RE: The following changes, additions, and/or deletions are hereby made a part of the *Water System Design and Construction Standards* dated November 2019 for projects designed for installation in the Tualatin Valley Water District's system, as fully and completely as if the same were set forth therein. The updates are now included in the document titled *Water System Design and Construction Standards* dated September 2020 and can be found on the District's website (www.tvwd.org/standards). All changes to the November 2019 document are listed below.

There are 24 pages included in this Addendum No. 1.

REVISIONS:

302

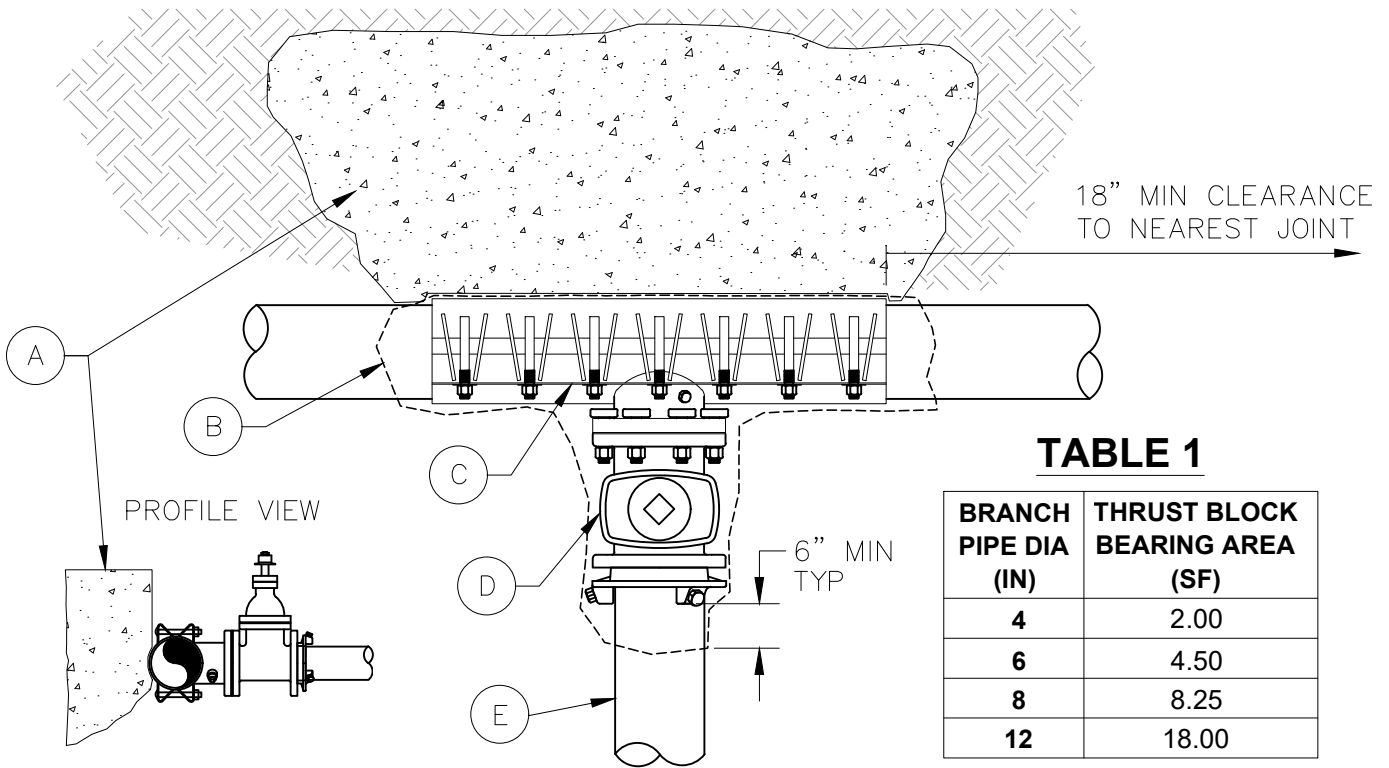
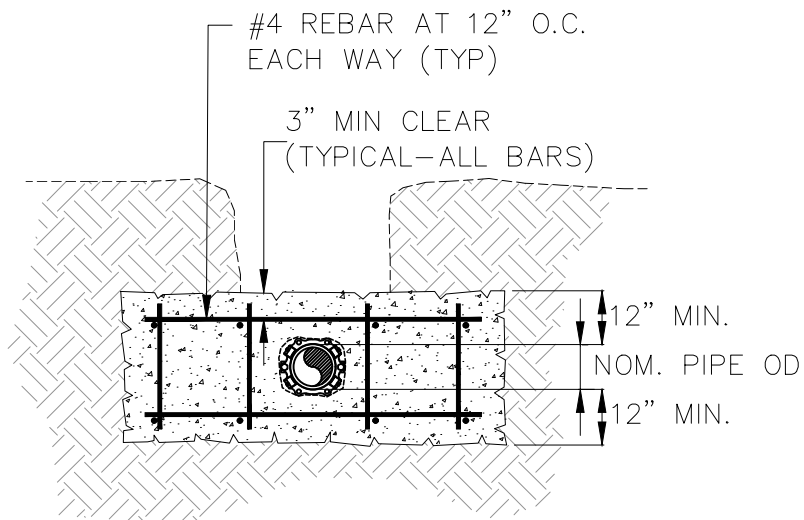
24. Modified Detail 302 Table 1 to include updated Thrust Block Bearing Area (SF).
 25. Modified Detail 302 & 304, added “SAFETY FACTOR SHALL BE 1.5.” on Note 7 Detail 302, and added “AND INCLUDE A SAFETY FACTOR OF 1.5.” to Note 1 Detail 304.
-

BRANCH PIPE DIA (IN)	THRUST BLOCK BEARING AREA (SF)
4	2.00
6	4.50
8	8.25
12	18.00

- 1. BEFORE INSTALLING TAPPING SADDLE, CONTRACTOR SHALL THOROUGHLY CLEAN PIPE TO REMOVE ALL DIRT, ROCKS, AND OTHER FOREIGN MATERIAL FROM PIPE WHERE SADDLE WILL BE INSTALLED.
- 2. SADDLE BOLTS SHALL BE TORQUED TO MANUFACTURER'S SPECIFICATIONS. BOLTS SHALL CONFORM TO ANSI/AWWA C111/A21.11.
- 3. CONTRACTOR SHALL ENSURE THAT GASKET IS PROPERLY ALIGNED AND FREE OF FOREIGN MATERIAL PRIOR TO TIGHTENING SADDLE.
- 4. SADDLE LOCATION AND INSTALLATION SHALL BE APPROVED BY DISTRICT INSPECTOR PRIOR TO TAPPING.
- 5. CONTRACTOR SHALL AIR TEST SADDLE TO 40 PSI PRIOR TO TAPPING.
- 6. CONTRACTOR SHALL FLUSH AND PRESSURE TEST VALVE FOR PRIOR TO BACKFILLING.
- 7. ENGINEER SHALL PROVIDE CALCULATION AND SIZING IF TEST PRESSURE EXCEEDS 150 PSI. SAFETY FACTOR SHALL BE 1.5.

304

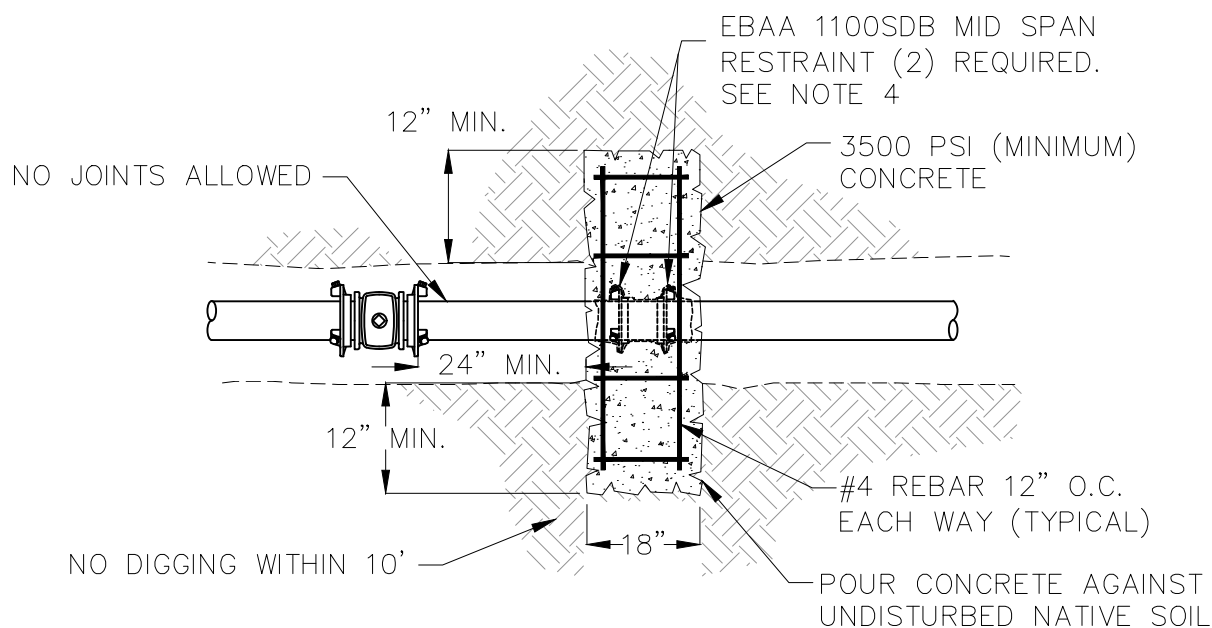
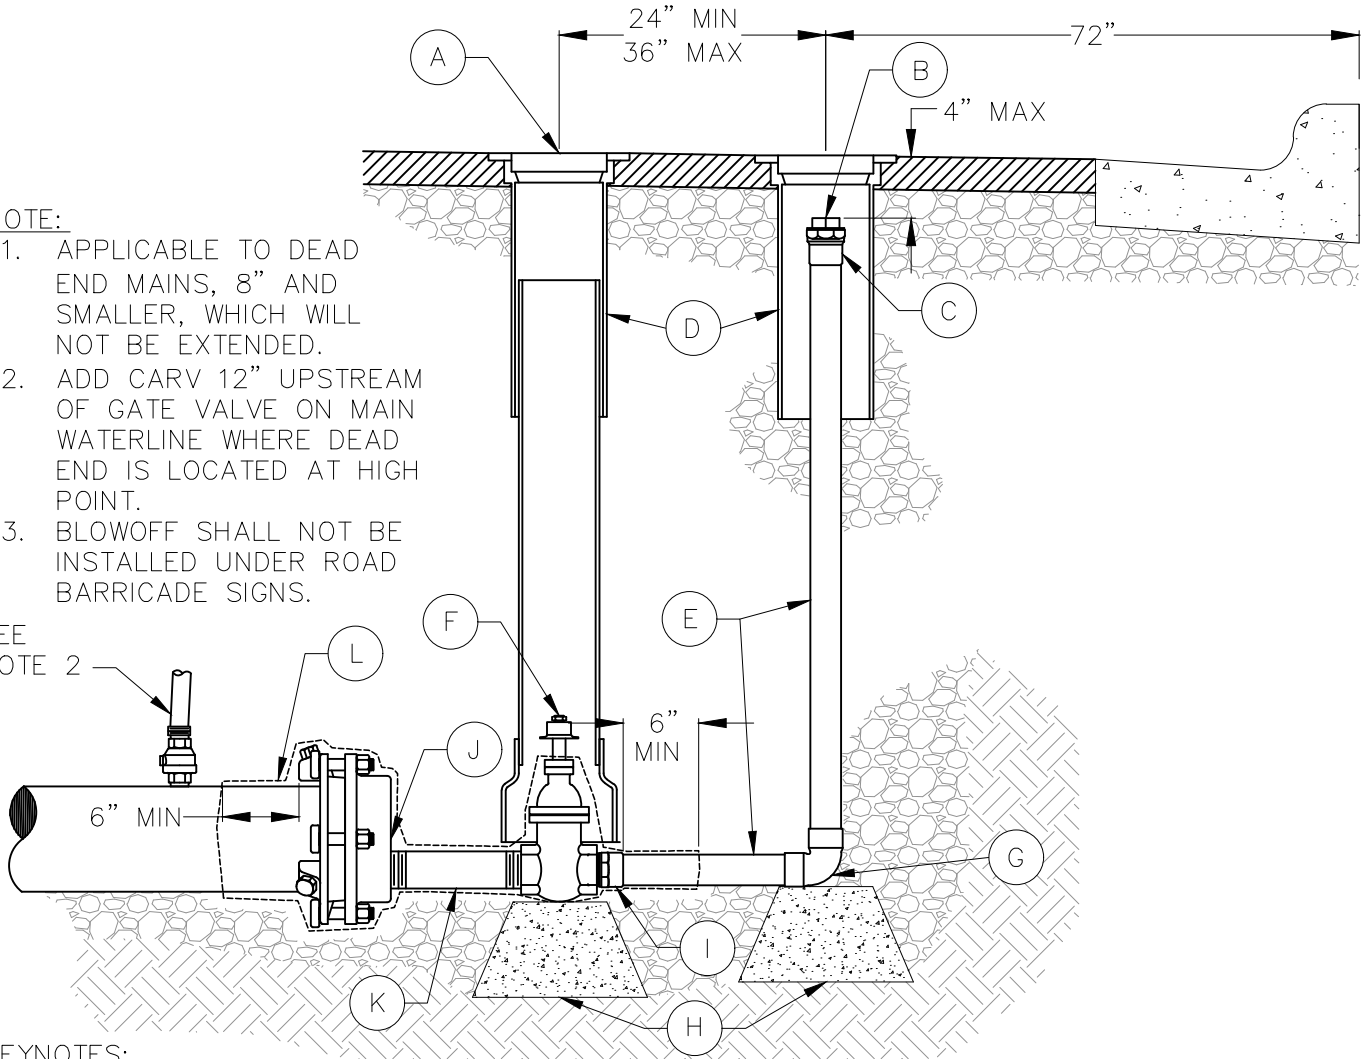
26. Modified Detail 304 to call out "PROJECT ENGINEER" on Note 1, replacing "PROJECT ENGINEER OF RECORD".
 27. Modified Detail 304 Note 5 to include "ENGINEER SHALL PROVIDE DESIGN AND SUPPORTING CALCULATIONS IF TEST PRESSURE EXCEEDS 150 PSI".

1. CONCRETE STRADDLE BLOCKS FOR 12" AND LARGER MAINS SHALL BE DESIGNED AND STAMPED BY THE PROJECT ENGINEER. PROVIDE CALCULATIONS FOR REVIEW AND APPROVAL, AND INCLUDE A SAFETY FACTOR OF 1.5.
2. USE 2" OFFSET OR MANUFACTURER RECOMMENDATION FOR MID-SPAN RESTRAINT.
3. TIE REBAR TO ITSELF TO HOLD FORM.
4. WRAP RESTRAINTS WITH 1 LAYER OF POLYETHYLENE ENCASEMENT PRIOR TO POURING CONCRETE. EXTEND PE WRAP A MINIMUM OF 6" BEYOND RESTRAINTS. SECURE TO PIPE WITH 10 MIL PVC PIPE WRAP TAPE
5. ENGINEER SHALL PROVIDE DESIGN AND SUPPORTING CALCULATION IF TEST PRESSURE EXCEEDS 150 PSI.

306

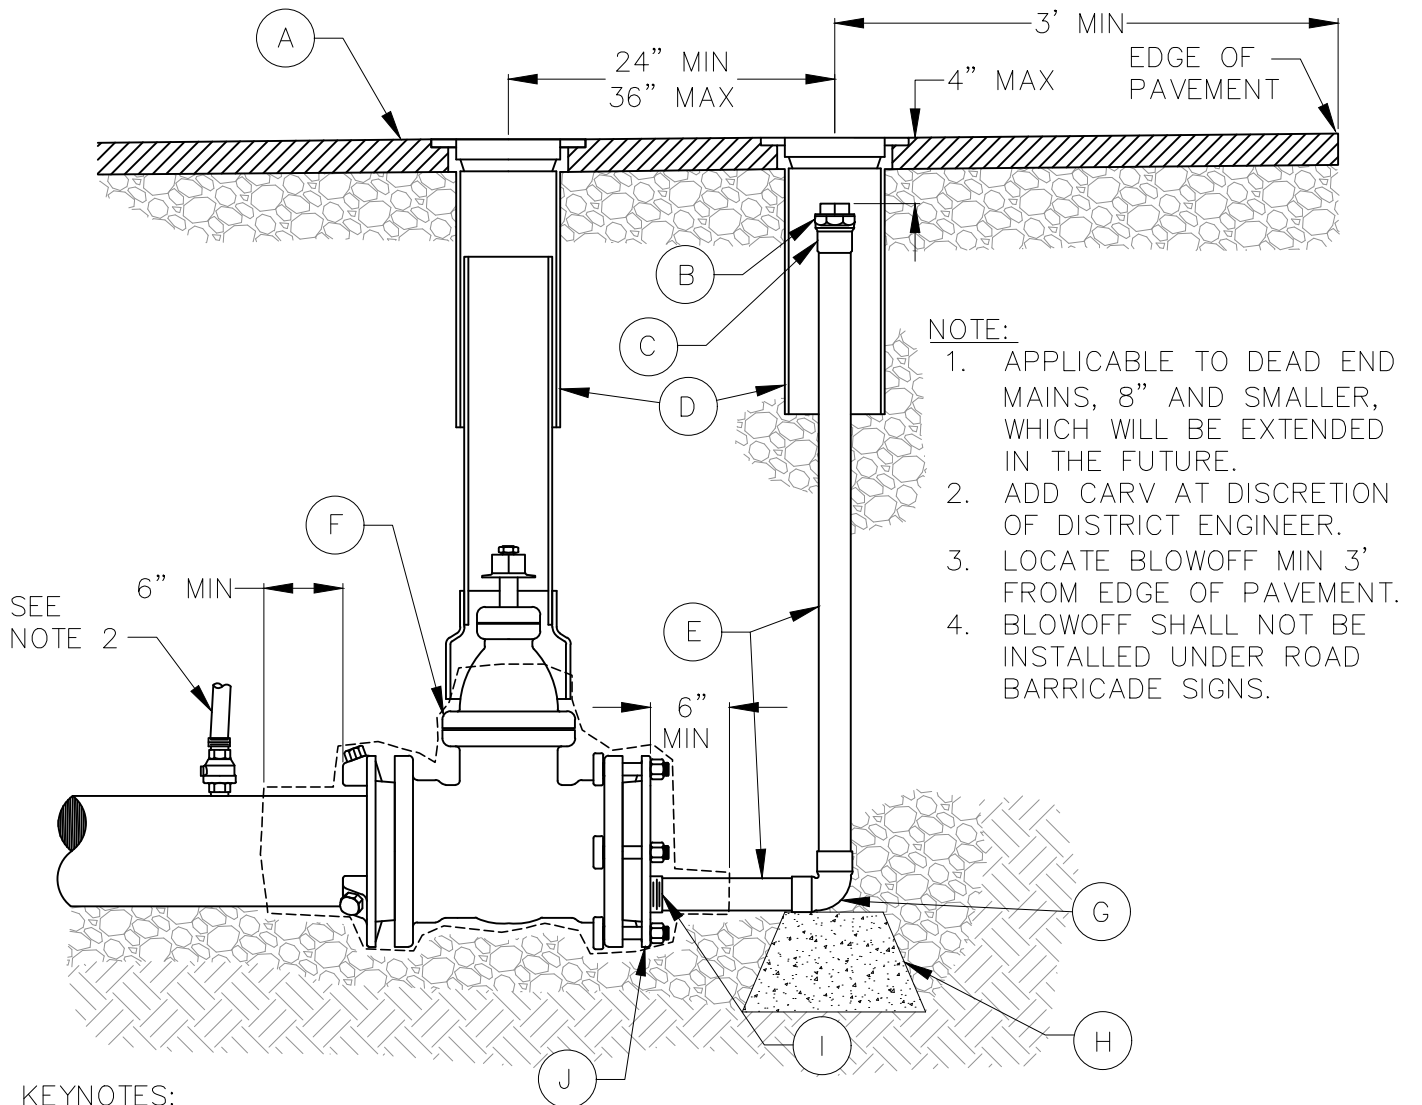
28. Modified Detail 306, added Note 3 "BLOWOFF SHALL NOT BE INSTALLED UNDER ROAD BARRICADE SIGNS."
 29. Modified Detail 307, added Note 4 "BLOWOFF SHALL NOT BE INSTALLED UNDER ROAD BARRICADE SIGNS."

1. APPLICABLE TO DEAD END MAINS, 8" AND SMALLER, WHICH WILL NOT BE EXTENDED.
2. ADD CARV 12" UPSTREAM OF GATE VALVE ON MAIN WATERLINE WHERE DEAD END IS LOCATED AT HIGH POINT.
3. BLOWOFF SHALL NOT BE INSTALLED UNDER ROAD BARRICADE SIGNS.

DETAIL
309

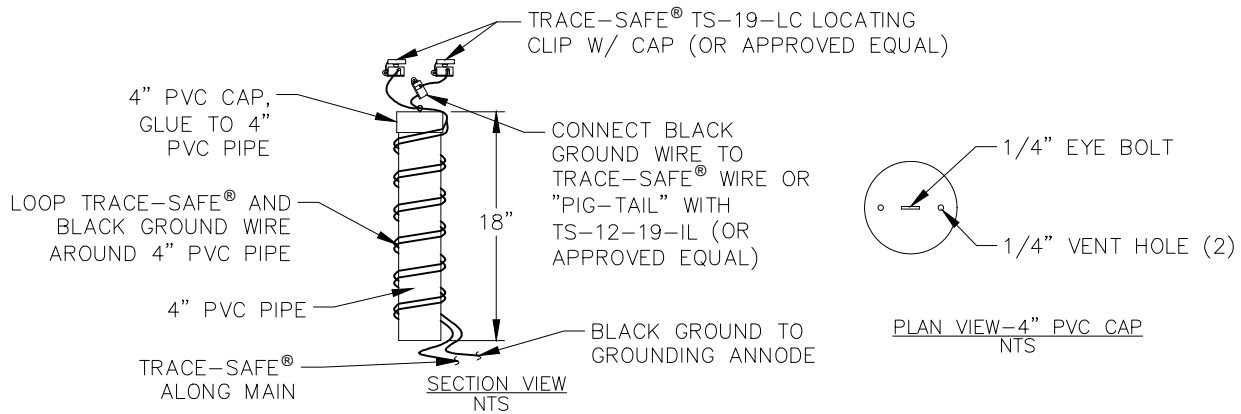
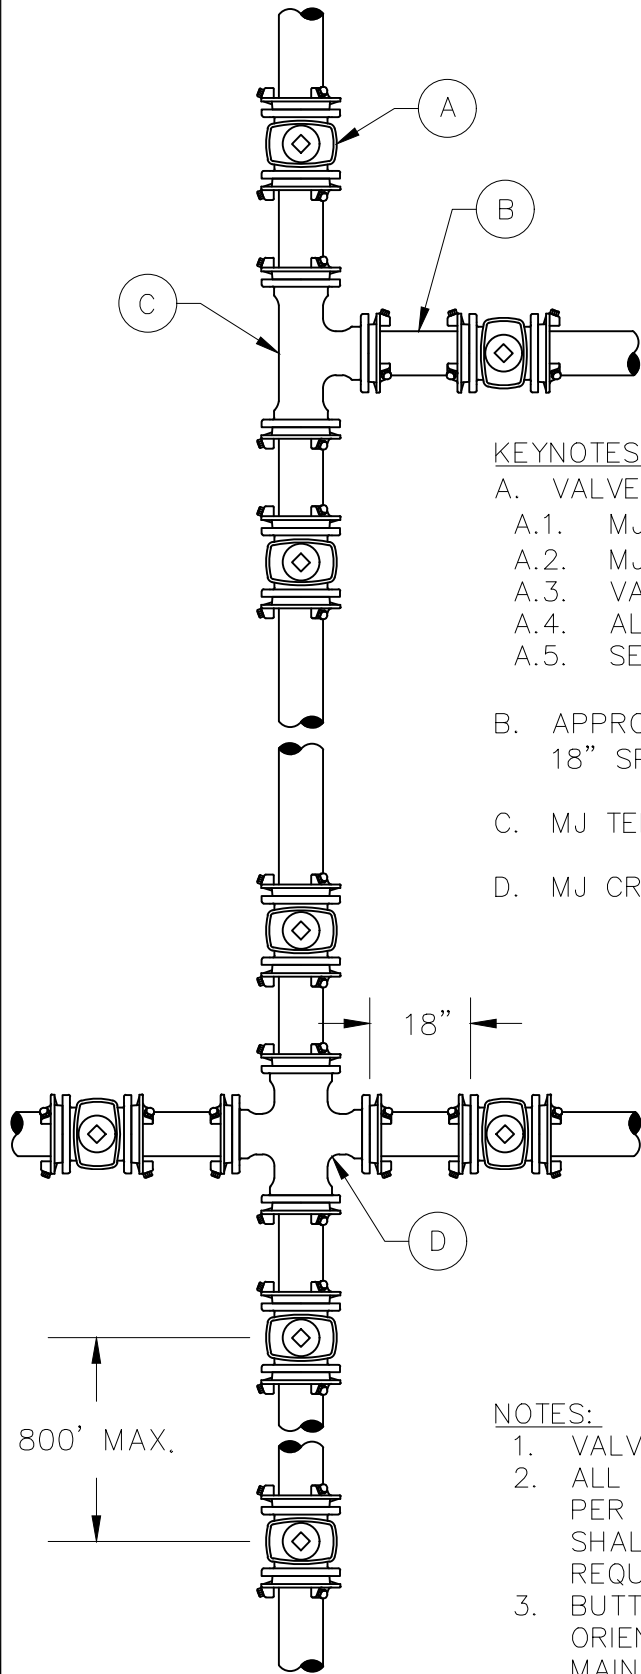
30. Modified Detail 309 Note 4 to read "INSTALL ON MAINS DEEPER THAN 5 FEET...", replacing "INSTALL ON MAINS DEEPER THAN 7 FEET..."
 31. Modified Detail 401 Note B to read "APPROXIMATELY 24" SPOOL REQUIRED TO ALLOW FOR 18" SPACING BETWEEN FITTINGS".

TUALATIN VALLEY WATER DISTRICT	DESIGNED: MBA	FIRE HYDRANT CLEAR ZONE	DATE: 9/2020
	APPROVED: NWA		DETAIL
	SCALE: NONE		503

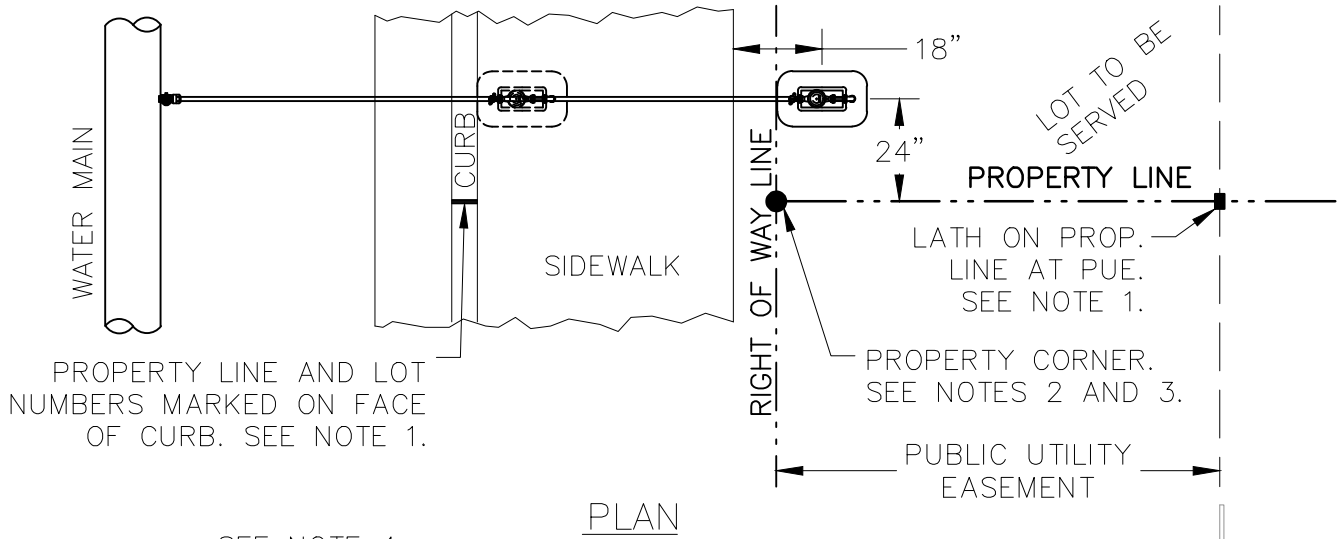
32. Modified Detail 503, added Note 4 "WHERE ALLOWABLE WITHIN CITY OR COUNTY JURISDICTIONS, HYDRANTS MAY BE PLACED WITHIN THE SIDEWALK, IF THE SPACING REQUIREMENTS ARE MET AS SHOWN.". Added sidewalk dimensions to indicate the requirements of Note 4.

3. THE CONTRACTOR SHALL INSTALL A BLUE REFLECTOR BUTTON FOR THE FIRE DEPARTMENT AFTER FINAL LIFT OF AC PAVEMENT IS PLACED.
4. WHERE ALLOWABLE WITHIN CITY OR COUNTY JURISDICTIONS, HYDRANTS MAY BE PLACED WITHIN THE SIDEWALK, IF THE SPACING REQUIREMENTS ARE MET AS SHOWN.

601

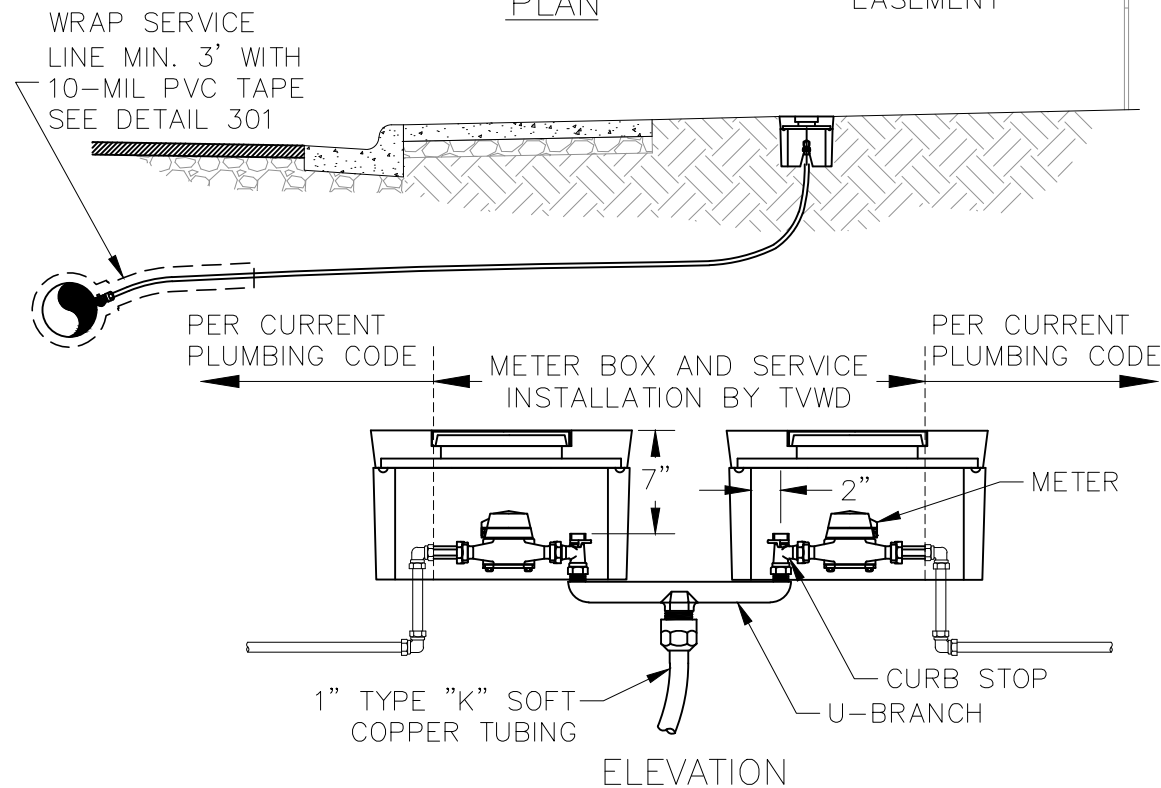
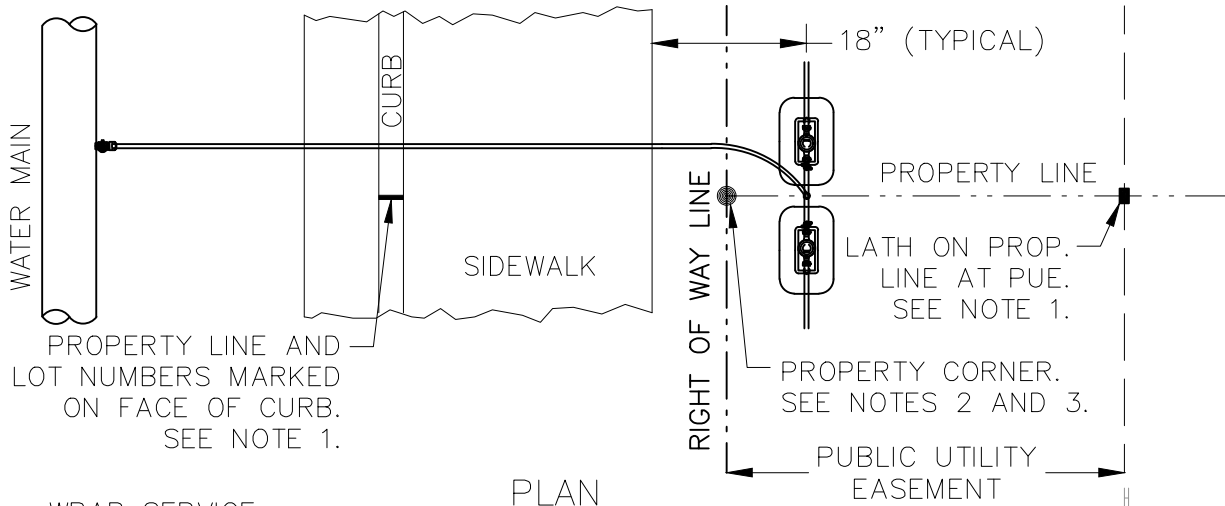
33. Modified Details 601-604 to call out "SEE SECTION 8.2 OF THE STANDARDS FOR BACKFLOW REQUIREMENTS" in the notes.
 34. Modified Details 606-610 to remove Note 4 "PAINT INTERIOR WALLS AND LID BOTTOM WHITE."

1. DEVELOPER'S SURVEYOR SHALL SET A LATH AT THE INTERSECTION OF THE PROPERTY LINE AND THE PUBLIC UTILITY EASEMENT. DEVELOPER'S SURVEYOR SHALL ALSO MARK THE PROPERTY LINE AND LOT NUMBERS ON THE FACE OF CURB WITH WHITE PAINT.
2. IF PROPERTY CORNER MONUMENTS HAVE NOT BEEN SET AT THE TIME OF WATER SERVICE INSTALLATION, THE DEVELOPER'S SURVEYOR SHALL SET A LATH AT THE PROPERTY CORNER LOCATION ON THE RIGHT-OF-WAY LINE.
3. ORS 92.044(7) PROHIBITS LOCATING ANY UTILITY INFRASTRUCTURE WITHIN 1-FT OF A SURVEY MONUMENT. DEVELOPER SHALL PAY FOR ANY RELOCATION OF SERVICES AND/OR METER BOXES FOUND TO FALL WITHIN 1-FT OF A SURVEY MONUMENT LOCATION.
4. METERS SHALL ONLY BE INSTALLED IN SIDEWALK IF APPROVED BY DISTRICT ENGINEER. SHOWN IN SIDEWALK FOR INFORMATION ONLY. BOXES SHALL BE INSPECTED BY DISTRICT PRIOR TO POURING CONCRETE SIDEWALK.
5. SEE SECTION 8.2. OF THE STANDARDS FOR BACKFLOW REQUIREMENTS.
